Product Change Notification

Product Group: DD/Fri Aug 30, 2024/PCN-DD-027-2024-REV-0

Front-end Process Consolidation for 170V and 200V TMBS Products in SMPD package

Annex 1

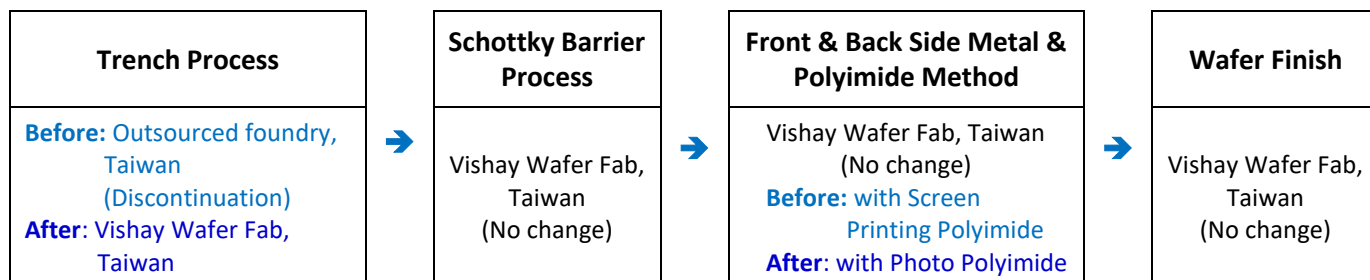
Description of Change: Vishay Diodes Division is announcing the front-end process consolidation for 170V and 200V TMBS (Trench MOS Barrier Schottky) products in SMPD package at Vishay wafer fab in Taiwan. This front-end process consolidation was already introduced before through PCN-DD-024-2023 and PCN-DD-032-2023. Meanwhile, the wafer polyimide coating method will be changed from screen printing to photo process for process consolidation. Please refer to Annex 1 for change view.

Front-end Process:
